Technical Service Information

FORD CD4E

NO FORWARD ENGAGEMENT AND/OR NO 3RD GEAR

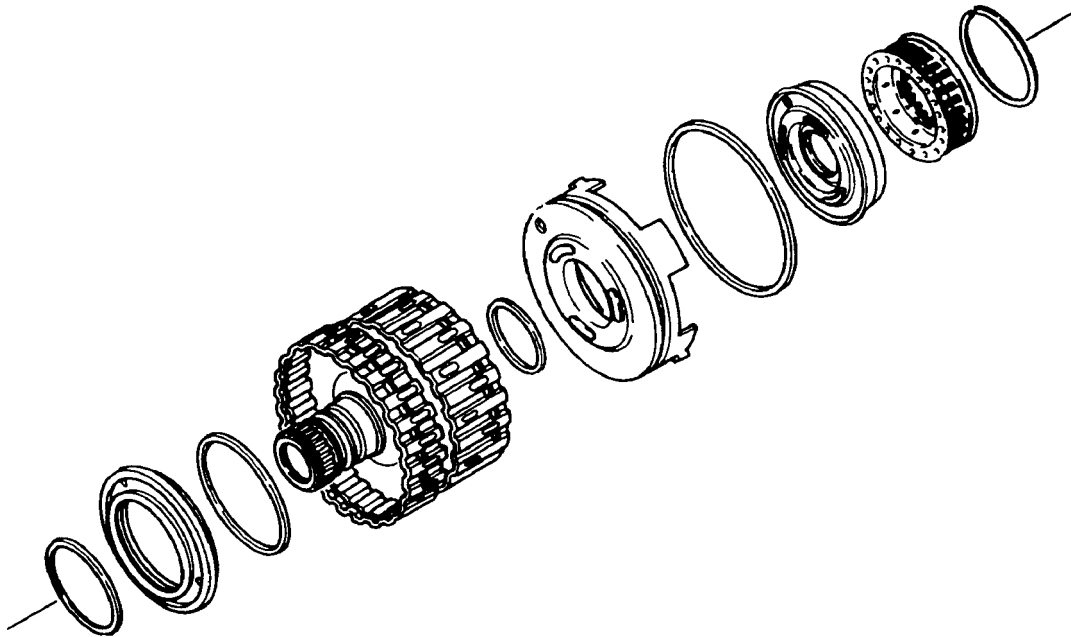
COMPLAINT: No forward engagement and/or no 3rd gear engagement may be present, before rebuild, on some CD4E transaxles built between Sept. 28, 1994 and Oct. 30, 1994. The transaxle serial numbers that are of concern are 4271-0000 thru 4303-9999.

CAUSE: The cause may be due to a defective weld condition on the Forward/Coast/Direct Clutch Cylinder, which results in fluid leakage from the forward clutch into the direct clutch. The clutch cylinder and hub weld condition may not be identifiable visually.

CORRECTION: When extensive wear is observed on the forward clutch plates and/or the direct clutch plates, and the transaxle serial number is 4271-0000 thru 4303-9999, built between the dates listed above, replace the Forward/Coast/Direct Clutch Cylinder Assembly with the appropriate service part number listed below.

| Clutch Cylinder and Hub Assembly (4 Cyl) | F5RZ-7G120-A |
| Clutch Cylinder and Hub Assembly (6 Cyl) | F4RZ-7G120-A |
